Product Change Notification

114002 - 00

Change Notification #: 114002 - 00
Change Title: Intel® Server System R1208JP4OC
PCN 114002-00, Label, Product Design
Update the Safety Label, Add a Mylar and a
Plastic Block & Add an ODD (Optical Disc
Drive) Accessory Kit
Date of Publication: August 3, 2015

Figure-3: Front Panel Mylar Change

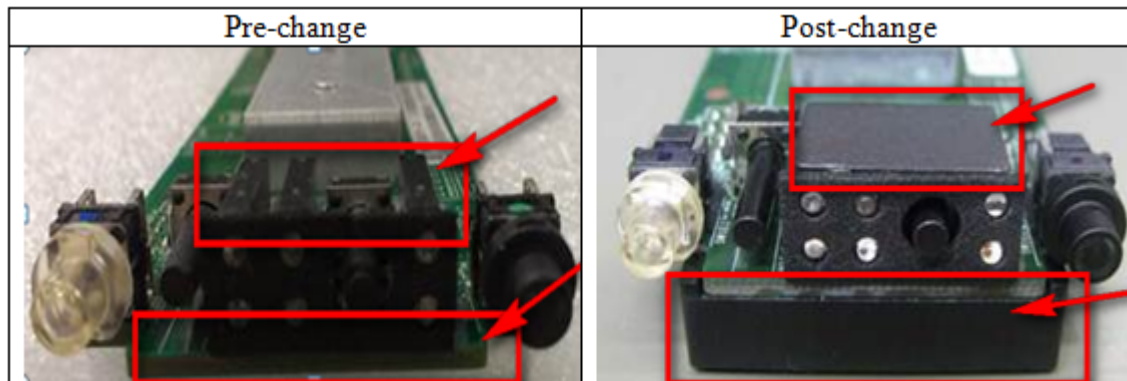
- Add a Mylar on the top of the front panel board and add a plastic block for the front end under the front panel board to hold parts more securely. See Figure-3 below:

Figure-4: ODD Accessory Kit

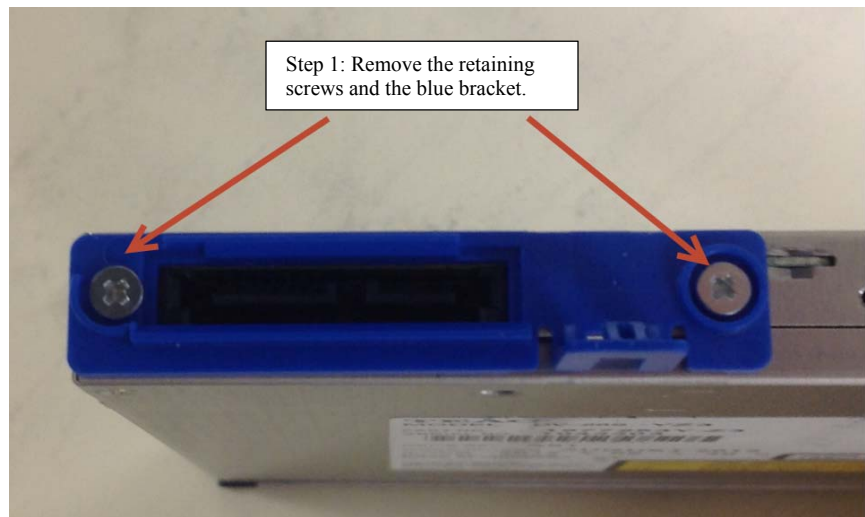
- Add an ODD accessory kit. See Figure-4 as below:

Customers can follow the two steps below to install the shim on the optical disc drive.
